## SUNDRY NOTICES AND REPORTS ON WELLS

APACHE REQUESTS TO MODIFY / CHANGE THE ORIGINAL PLANS FOR THE INTERIM RECLAMATION (IR) FOR THE FOLLOWING WELLS.

CROW FEDERAL 19H, I-10-17S-31E, 2280' FSL & 370' FEL, 3001541909  
CROW FEDERAL 20H, I-10-17S-31E, 2310' FSL & 370' FEL, 3001541910  
CROW FEDERAL 21H, I-10-17S-31E, 2340' FSL & 370' FEL, 3001541911

PLEASE SEE ATTACHED DIAGRAM OF REVISED PLAN.

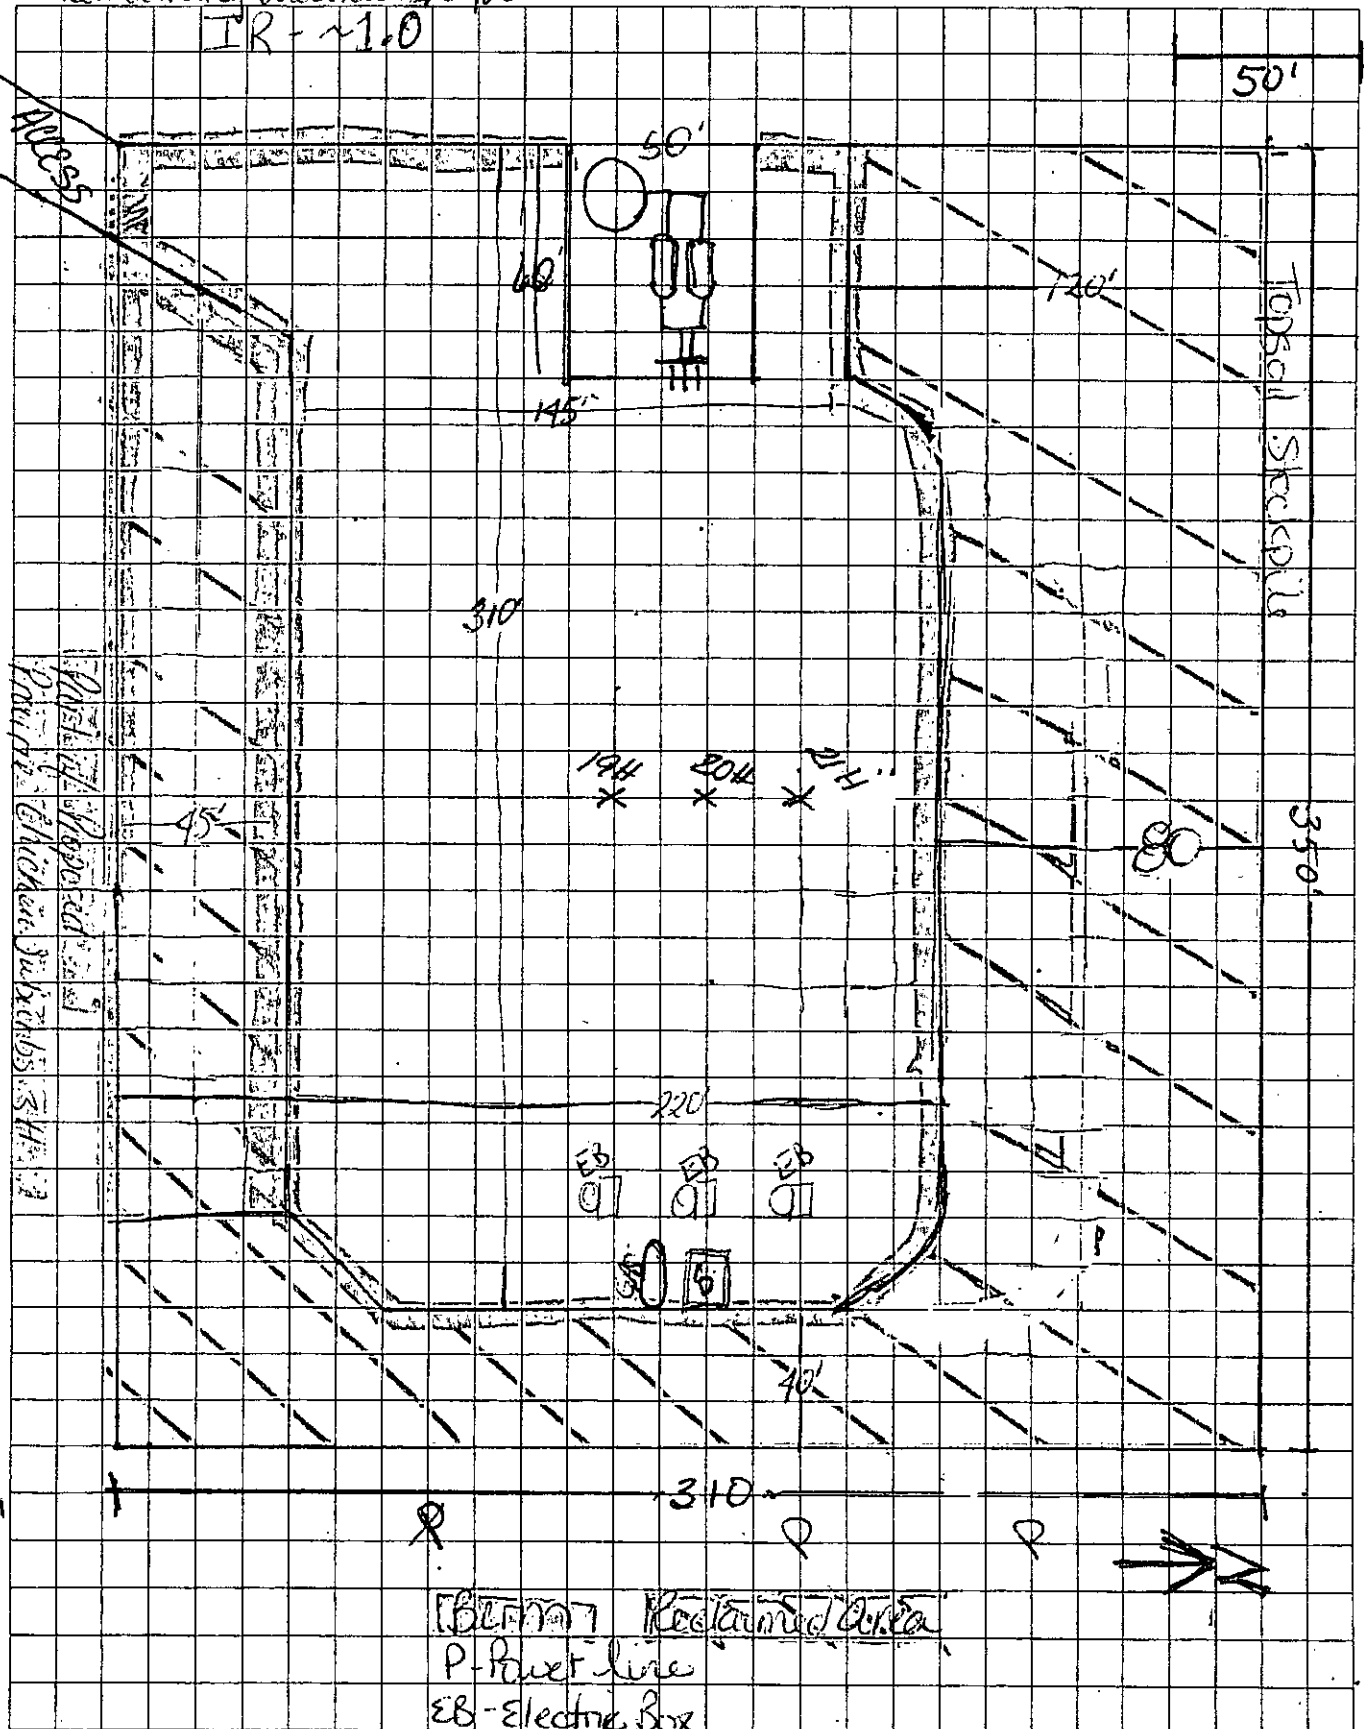
ORIGINAL PLANS DID NOT ACCOUNT FOR THE SATELLITE FACILITY LOCATED ON THE WEST JUST NORTH OF THE ACCESS ROAD. PLEASE SEE TABLE BELOW FOR ORIGINALLY PLANNED AND REVISED IR.

REVISED 310 x 350 FEET 2.49 SEE PLAT 1.42

APACHE PLANS TO MAKE UP THE 0.07 ACRE DIFFERENCE WITHIN THE SAME DEVELOPMENT AREA AND WILL BE TRACKED BY ARCADIS. IF PROPOSED PRAIRIE CHICKEN SUBURBS 3H IS NOT DRILLED PRIOR TO EXPIRATION OF PERMIT, THE 0.07+ ACRES WILL BE RECLAIMED ON THE SOUTH SIDE OF CROW FEDERAL 19H ? 21H WELL PAD.

IR WORK TO BE COMPLETED ? REMOVE CABLE, ANY FRAC SAND, AND UNUSED GRAVEL. PROPANE TANKS, IF STILL PRESENT, WILL BE REALIGNED TO MAXIMIZE THE IR ON THE EAST SIDE. CALICHE FREE OF ANY CONTAMINATION WILL BE REMOVED AND STOCKPILED FOR USE ON ROADS OR CONSTRUCTION OF WELL PADS. AREAS TO BE RECLAIMED WILL BE RECONTOURED TO MATCH SURROUNDING AREAS, THE TOPSOIL WILL BE DISTRIBUTED ACROSS ALL RECLAIMED AREAS, RIPPED ACROSS ANY SLOPED AREAS (NONE ANTICIPATED), AND SEEDED WITH BLM LPC SEED MIXTURE. WELL PAD WILL BE BERMED TO PREVENT CONTAMINANTS FROM LEAVING LOCATION IF AN UNDESIREABLE EVENT WAS TO OCCUR.

APACHE PLANS TO RECLAIM AFTER LAST WELL (21H) IS DRILLED AND COMPLETED.
